Town of Rolesville, NC
Department of Planning

Comments on #PSP-26-0002 - Planning & Zoning: Preliminary Subdivision Plat

Application Number: #PSP-26-0002
Application Type: Preliminary Subdivision Plat
Date: June 29, 2026
Address: 2206 Wait Ave Wake Forest NC 27587

OVERALL OPEN SPACE PLAN
C0.02

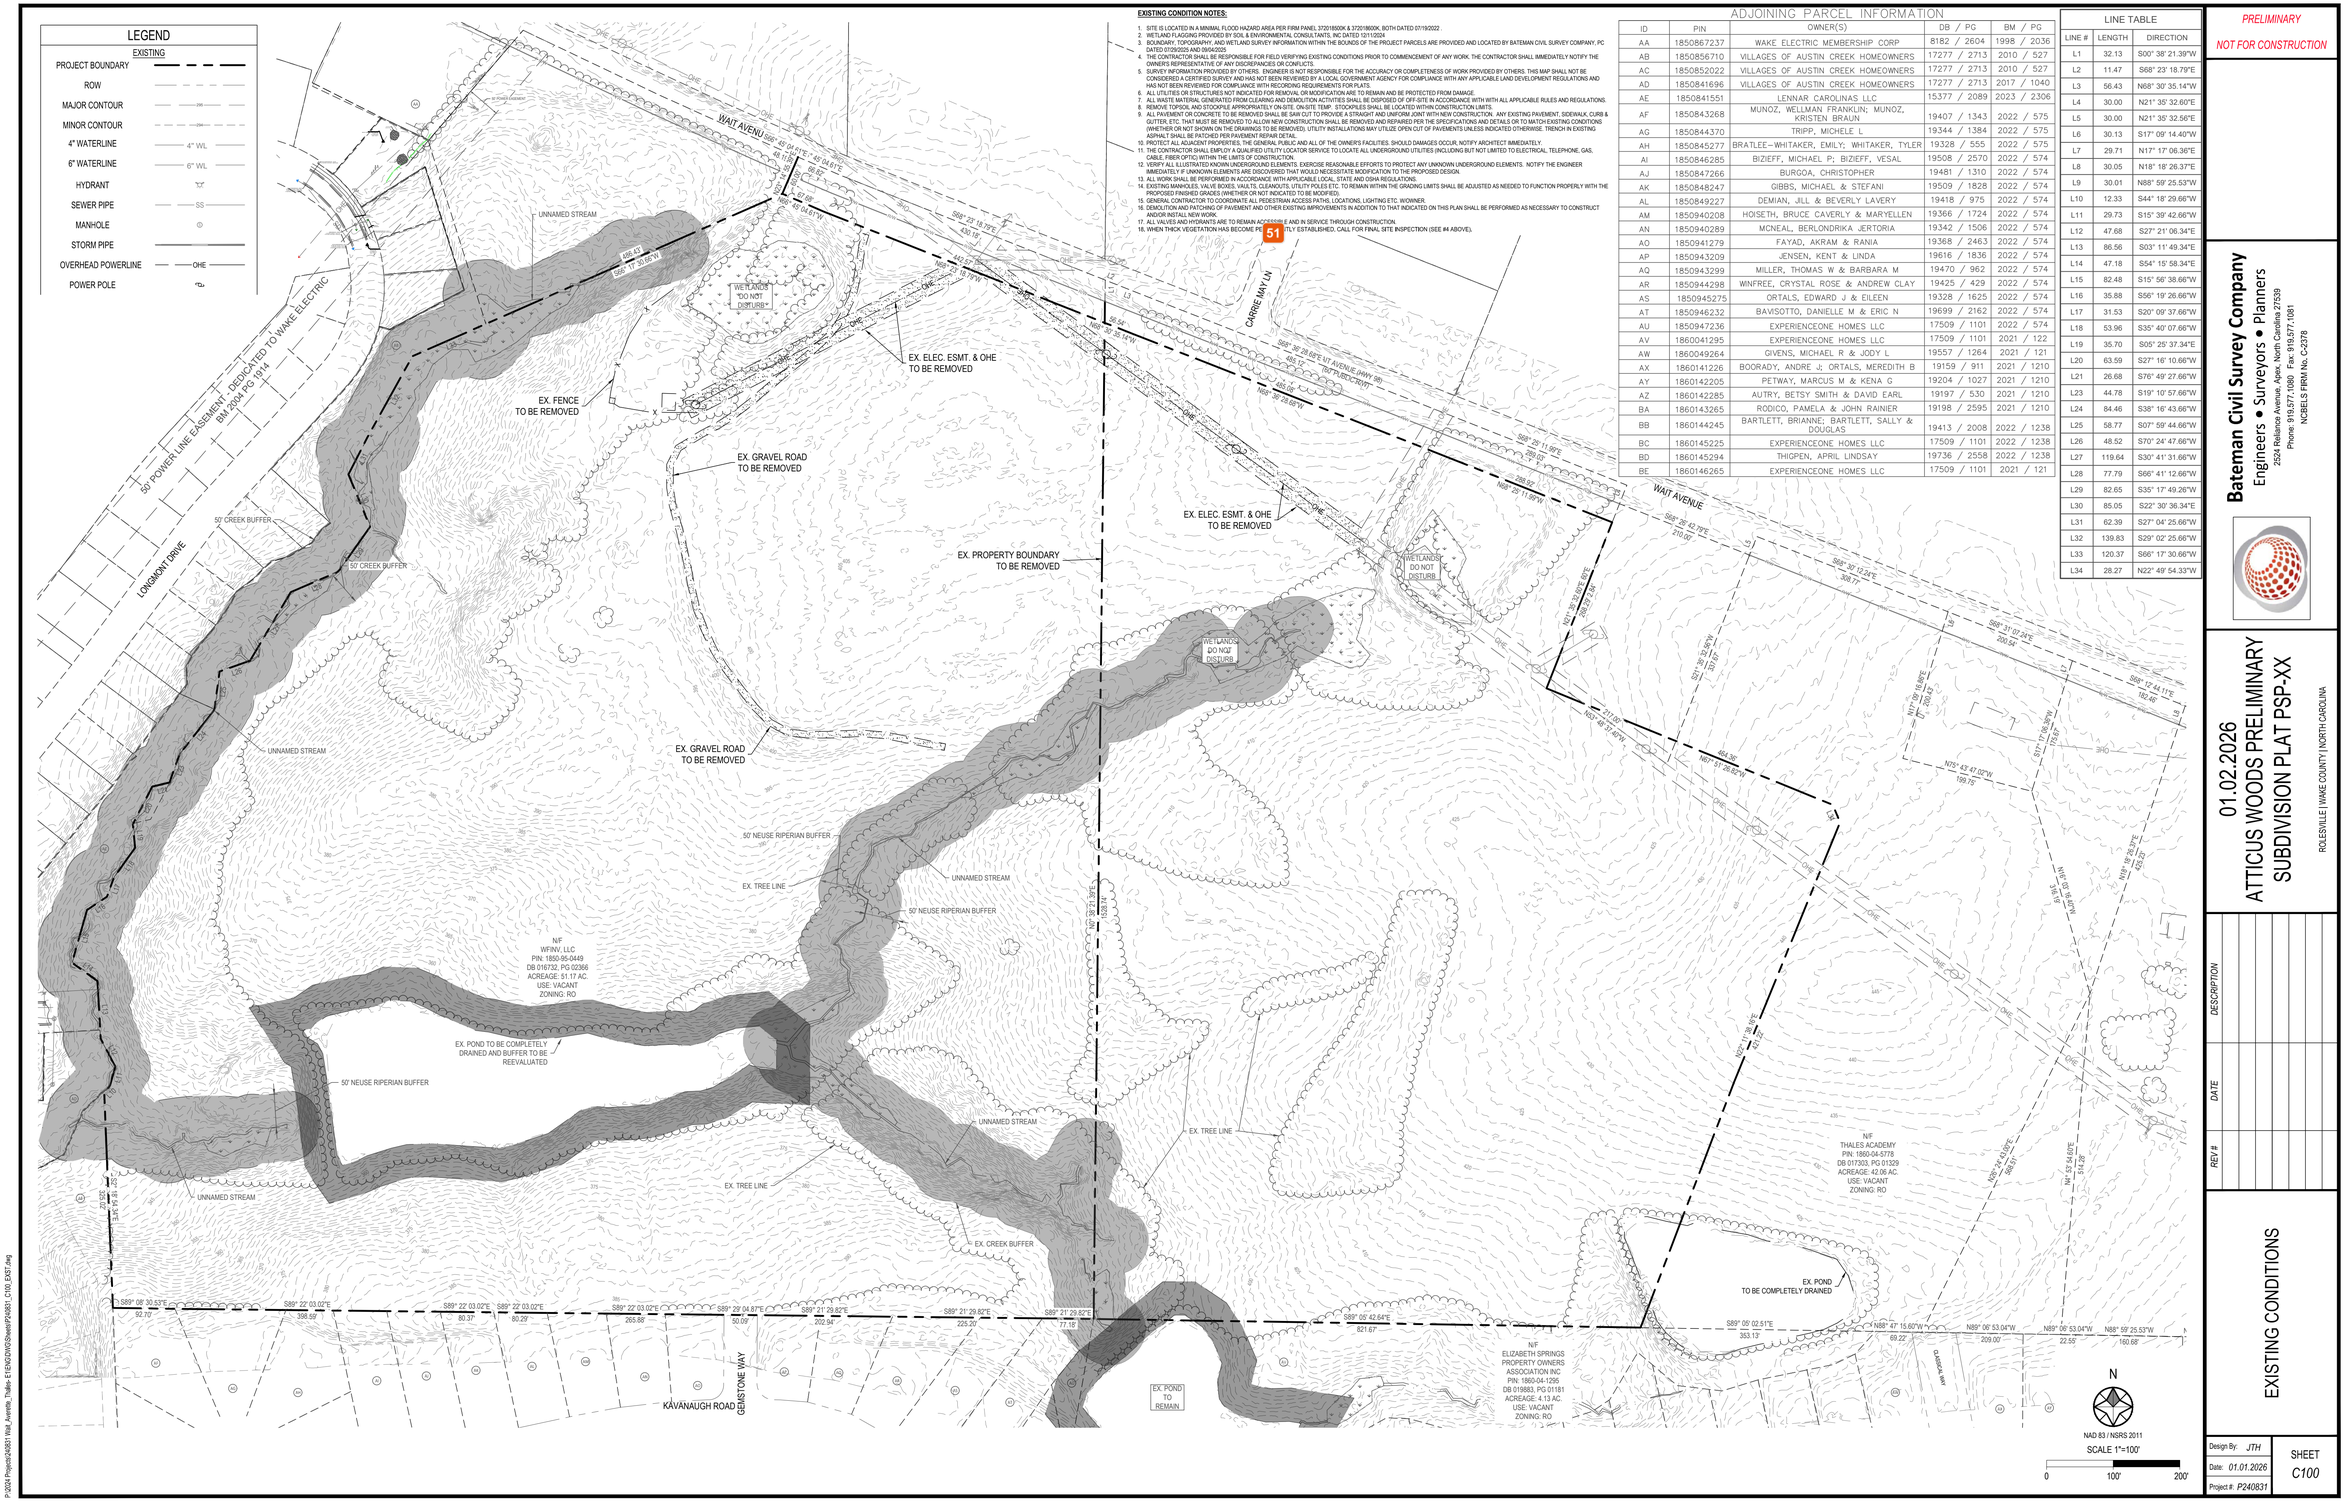
45 Michael Elabarger
This space would be a Street Buffer, not Perimeter - revise. 30' dimension is correct.

46 Stephen Wensman
The plans do not identify the Town's future park property as shown on Zoning approval

47 Jacqueline Thompson
Please label and provide required setbacks.

C2.04

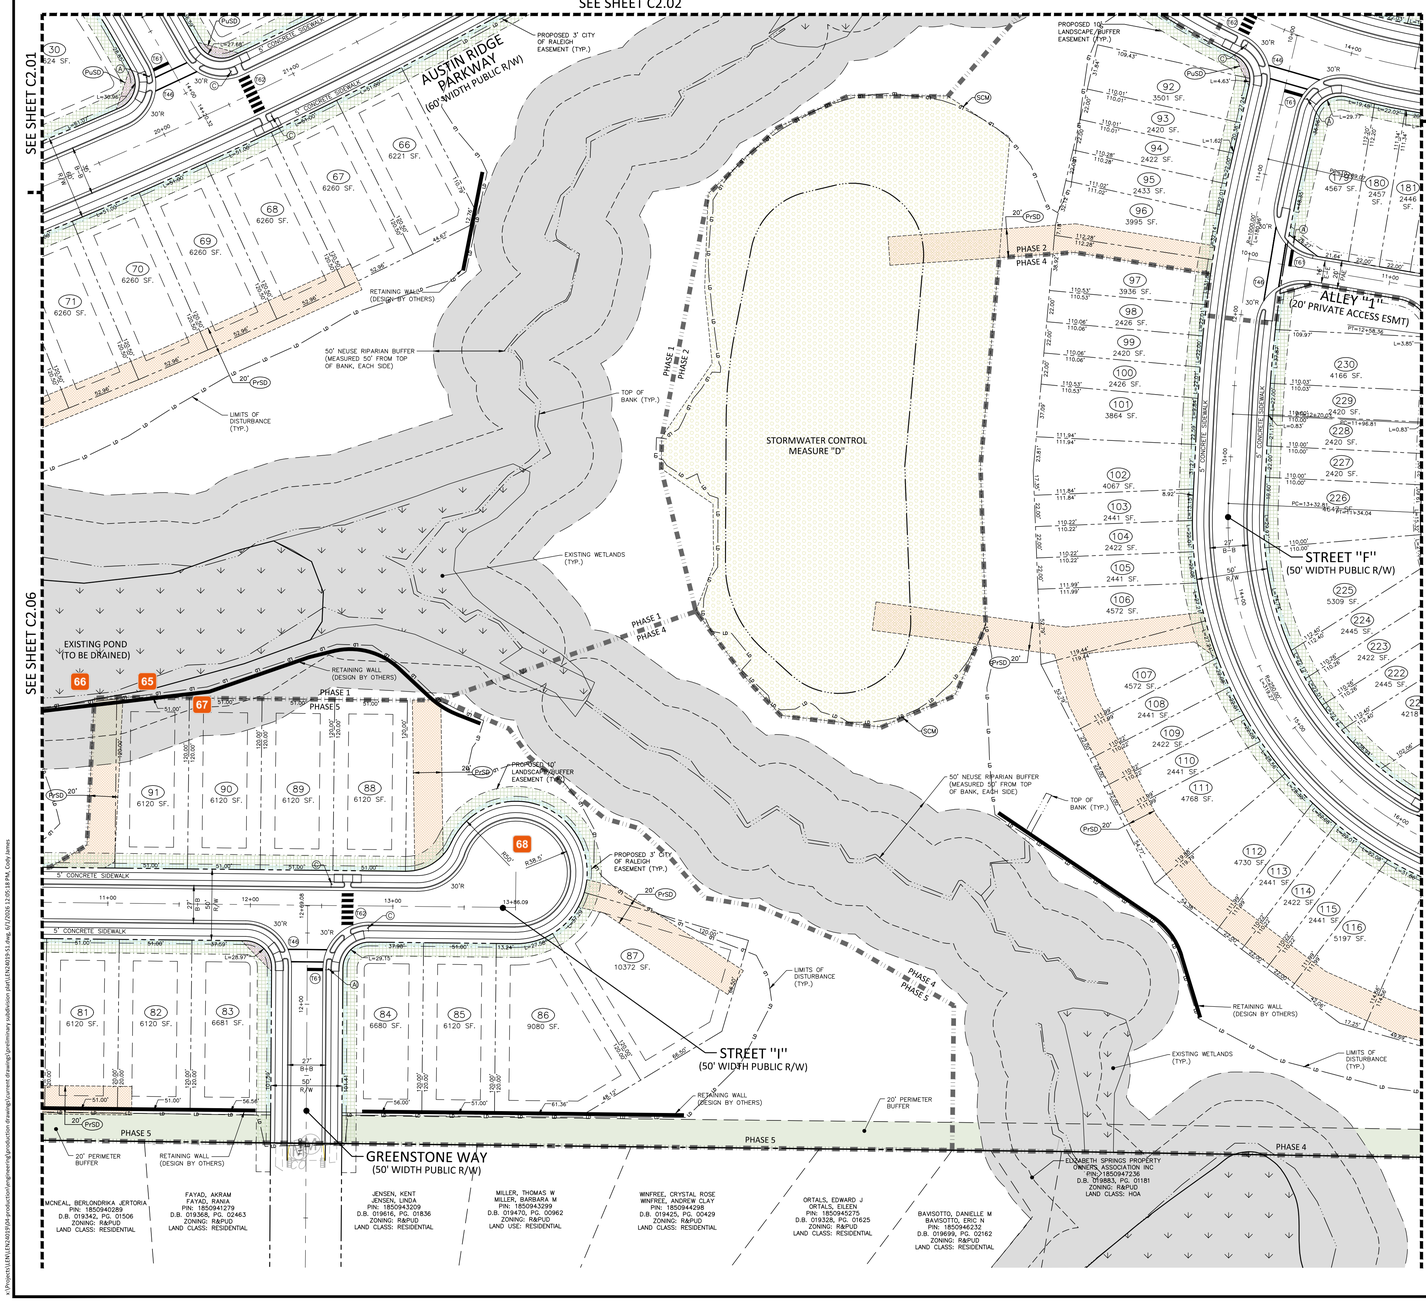
60 Jacqueline Thompson
This intersection is not encouraged. See the LDO for intersection design requirements.

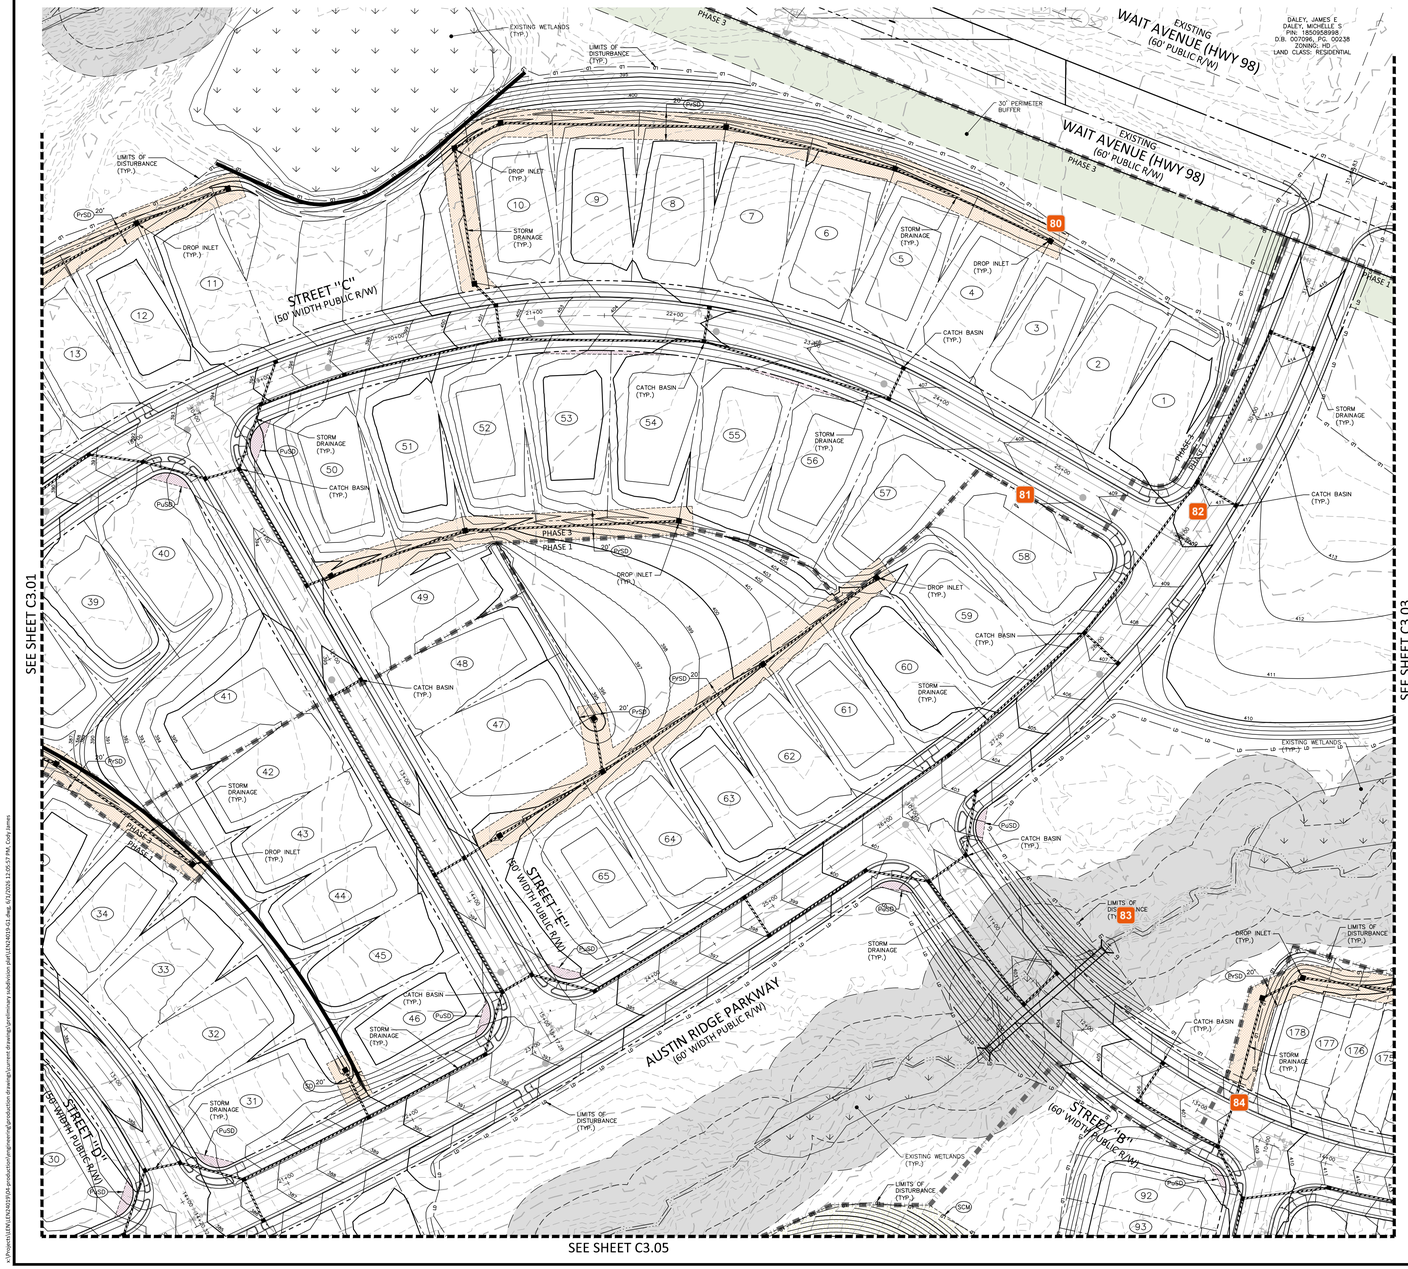
75 **Jacqueline Thompson**
For all SCMs, please provide access route and grade accordingly.

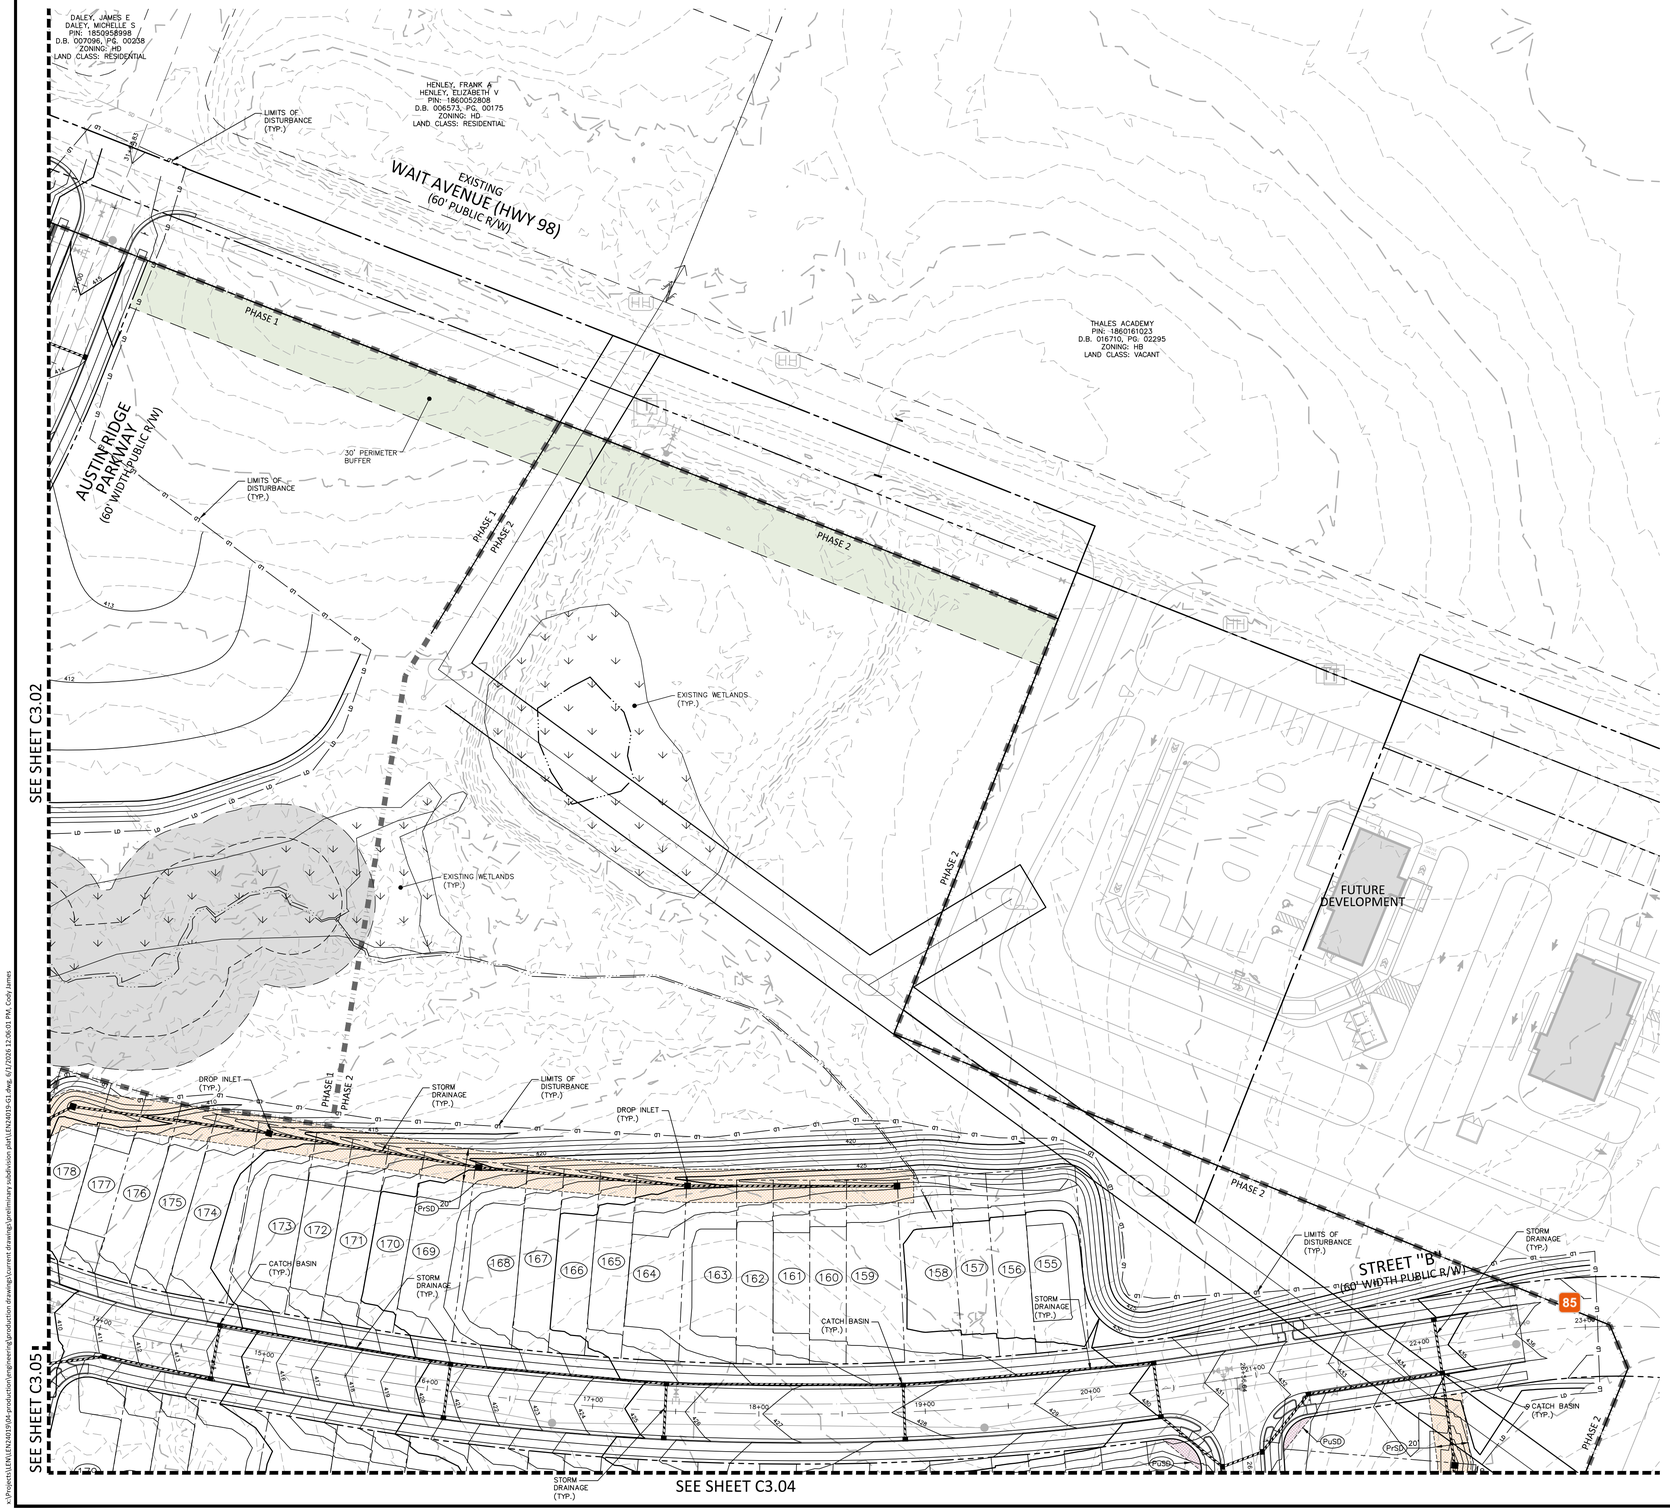
80 **Scott Miles**
all drainage easements not carrying "public water" to be private
